DESCRIPTION AND SAFETY ANALYSIS
OF PROPOSED CHANGE NPF-10/15-150

DESCRIPTION AND SAFETY ANALYSIS
OF PROPOSED CHANGE NPF-10/15-151

This is a request to revise Figure 3.1-2, "CEA Insertion Limits vs. Fraction of Allowable Thermal Power," of Technical Specification 3.1.3.6, "Reactivity Control Systems - Regulating CEA Insertion Limits," for San Onofre Nuclear Generating Station Units 2 and 3.

DESCRIPTION OF PROPOSED CHANGE NPF-10/15-152 AND SAFETY ANALYSIS

Figure 3.1-2

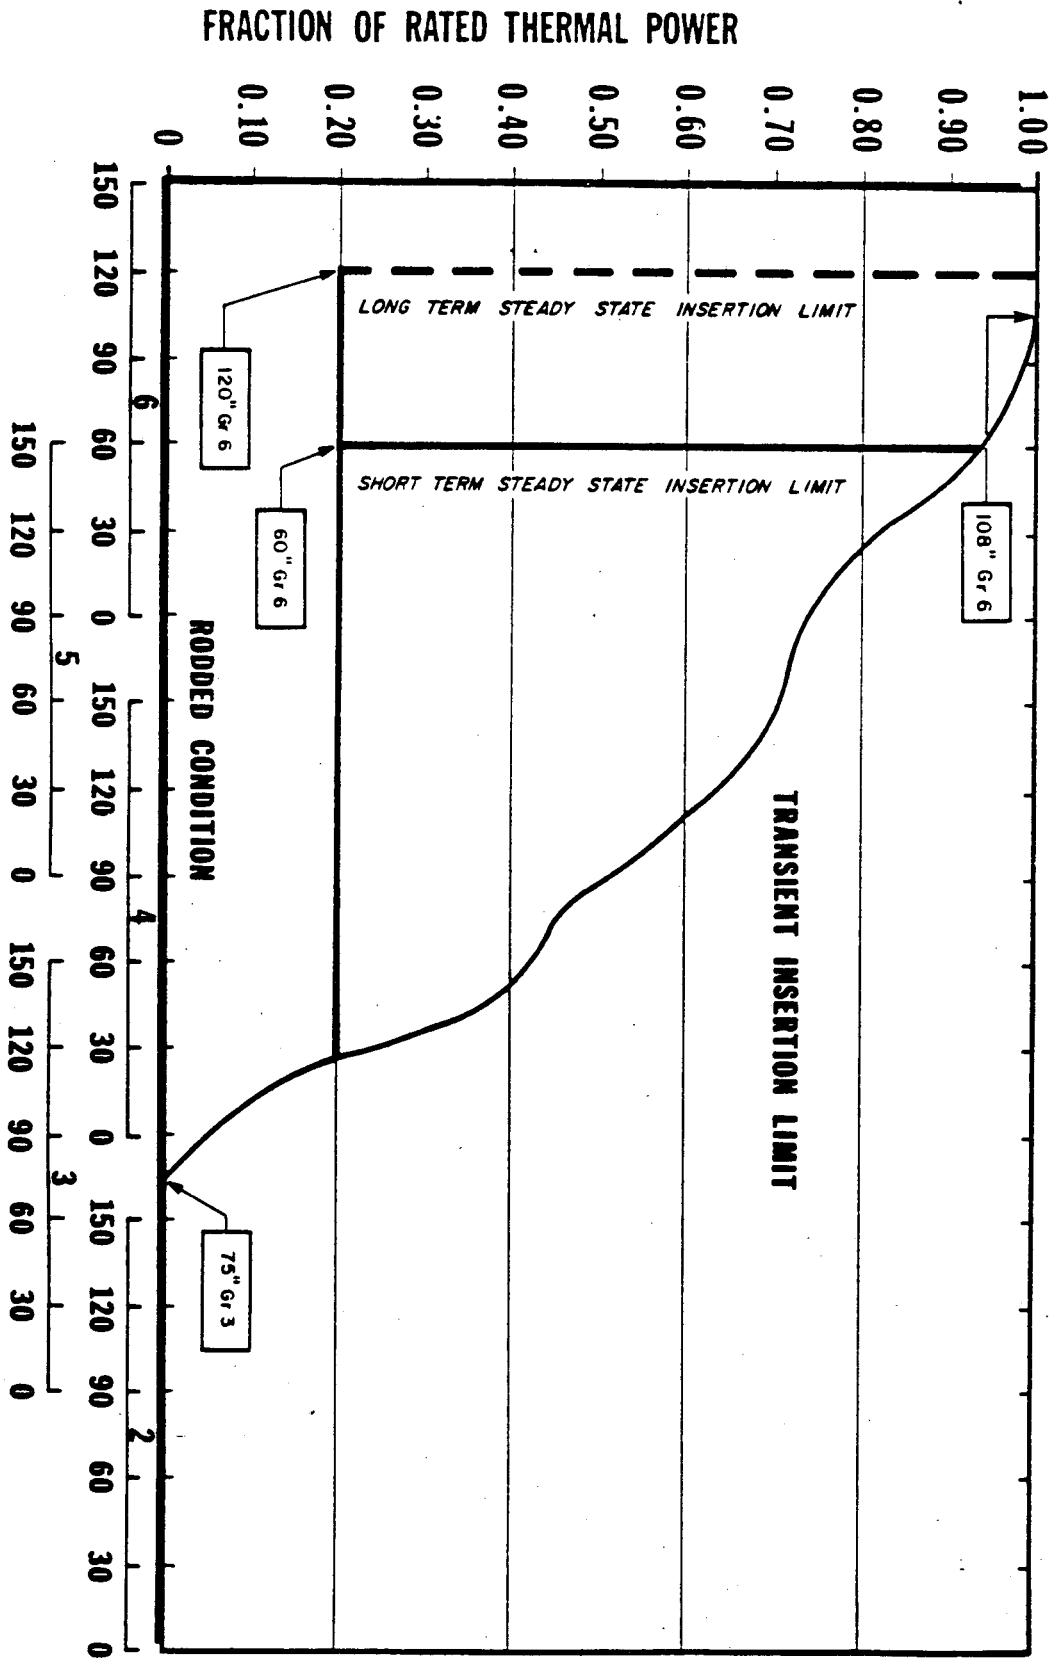
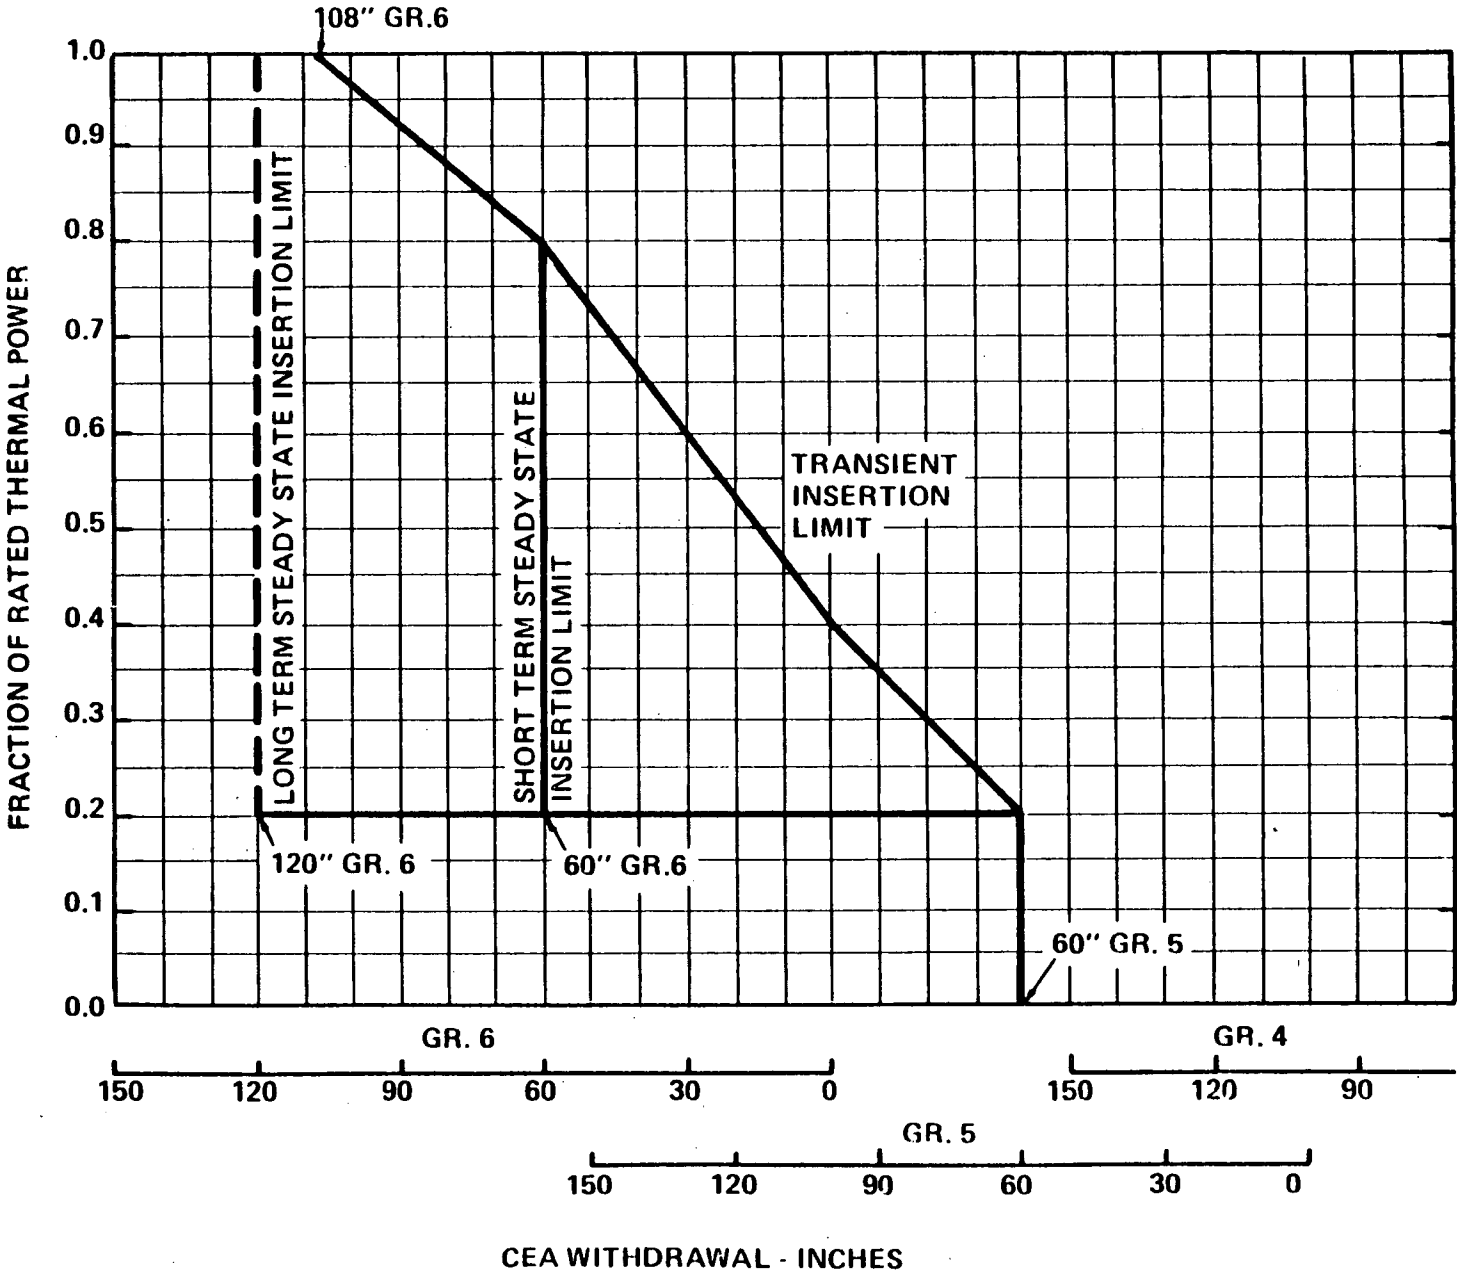
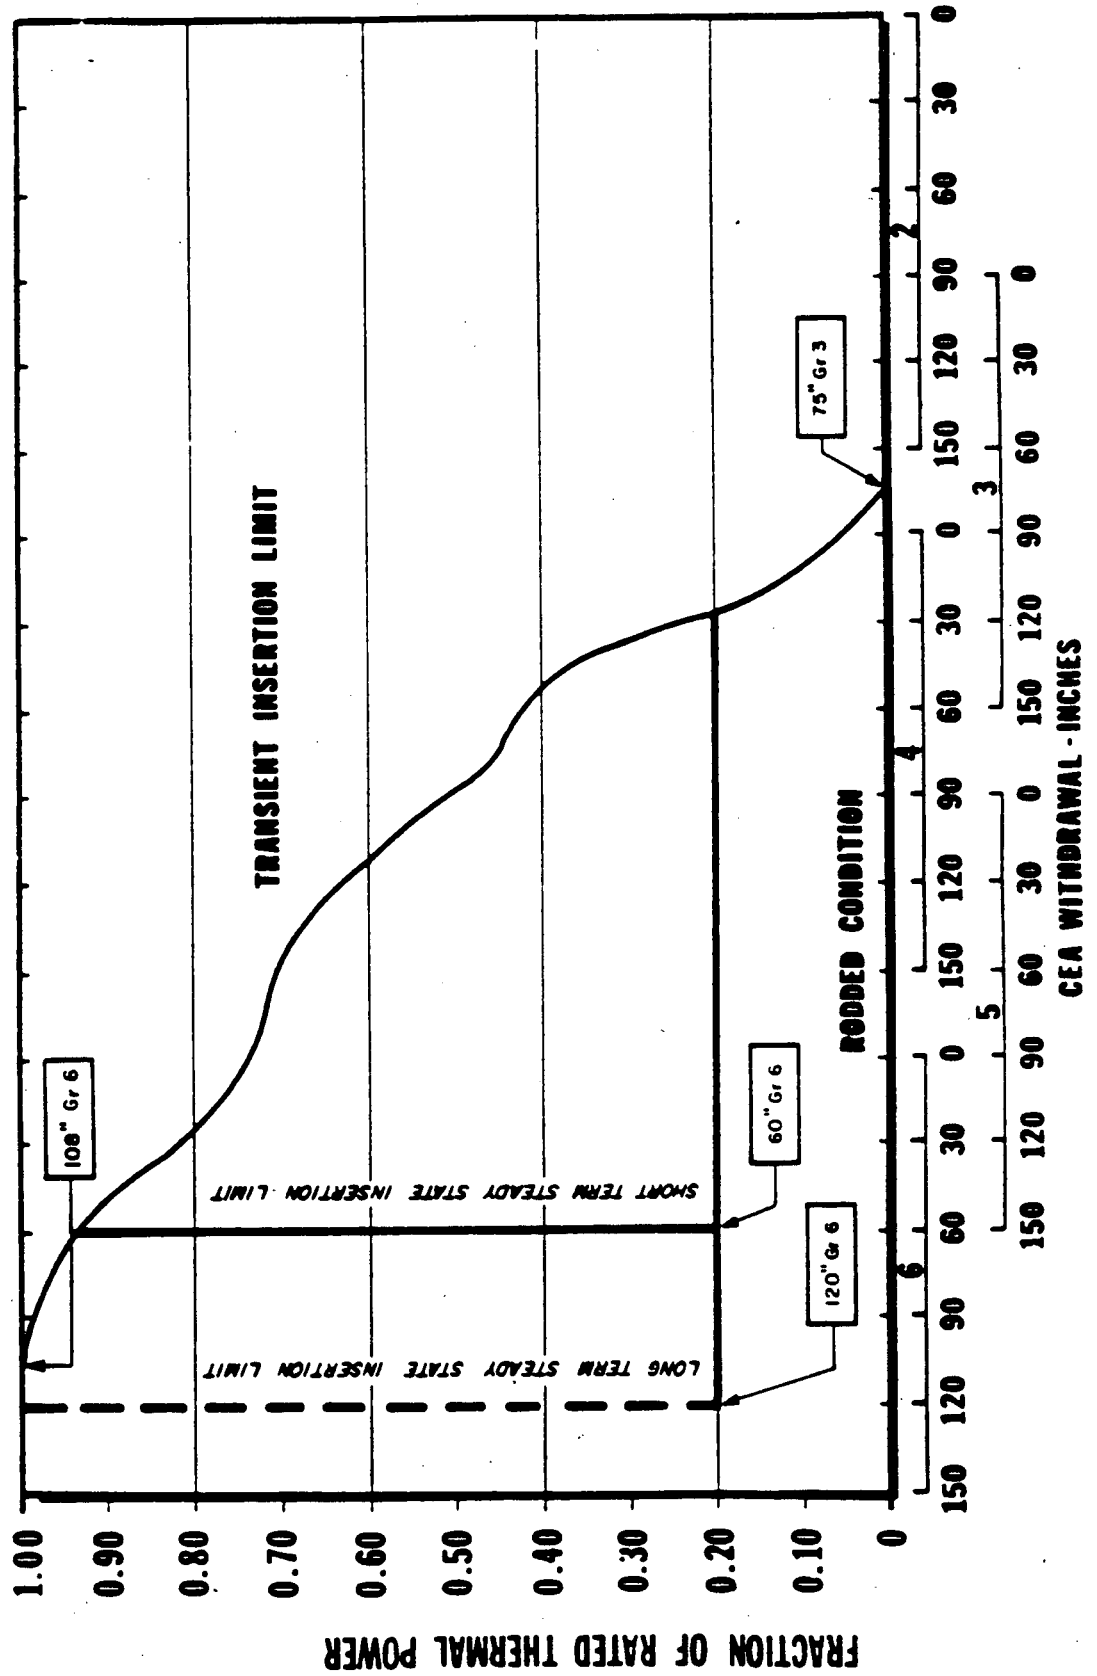
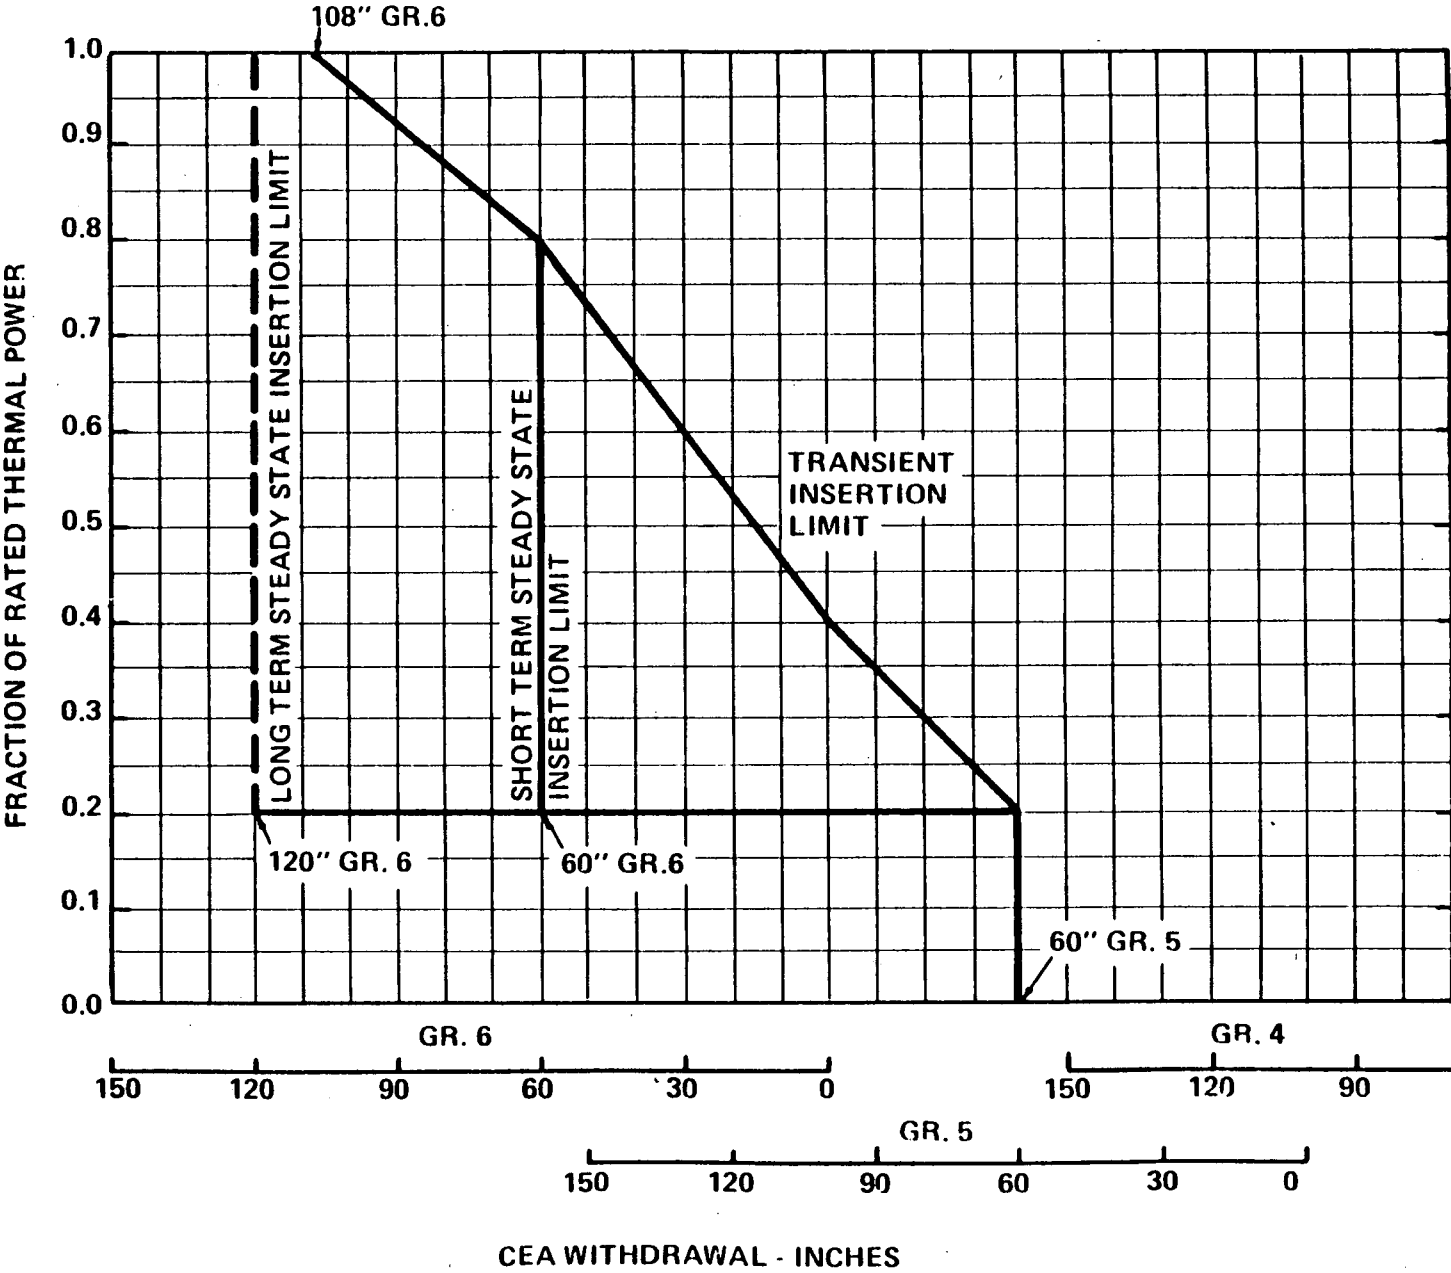
The proposed change will revise Figure 3.1-2, "CEA Insertion Limits vs. Fraction of Allowable Thermal Power," of Technical Specification (TS) 3.1.3.6, "Reactivity Control Systems - Regulating CEA Insertion Limits," which specifies the withdrawal sequence and Power Dependent Insertion Limits (PDIL) for the regulating Control Element Assembly (CEA) groups. The need for a specified withdrawal sequence and PDIL comes from the requirement that reactor design include appropriate margin to assure that specified acceptable fuel design limits are not exceeded during any condition of normal operation, including anticipated operational occurrences. To this end, TS 3.1.3.6 helps to ensure that (1) acceptable power distribution limits are maintained, (2) the minimum SHUTDOWN MARGIN is maintained, and (3) the potential effects of CEA misalignments are limited to acceptable levels.

TS 3.1.3.6 establishes the withdrawal sequence and PDIL. The proposed change will revise the Short Term Steady State Insertion Limit and Transient Insertion Limit specified by Figure 3.1-2. The Long Term Steady State Insertion Limit will remain unchanged. The proposed change to the Short Term Steady State Insertion Limit and Transient Insertion Limit constitutes an additional limitation or restriction which is not included in the existing Technical Specifications, but is included as an assumption in the Cycle 2 accident and transient analysis.

This restriction is imposed in order to reserve more margin for Steam System Piping Failure Inside and Outside Containment. (Standard Review Plan [SRP] Section 15.1.5) and the Spectrum of Rod Ejection Accidents (SRP Section 15.4.8). The results of these two accidents for Cycle 2 are typically more adverse than the results for Cycle 1 due to inherent differences between a first cycle core and reload cores. The safety analysis performed in support of the Cycle 2 reload effort, which includes the two accidents specifically mentioned above, uses assumptions that are consistent with the proposed change

to the PDIL. The safety analysis results were clearly within all acceptance criteria. Further, it is pointed out that the proposed change constitutes an additional limitation or restriction not included in the existing technical specifications.
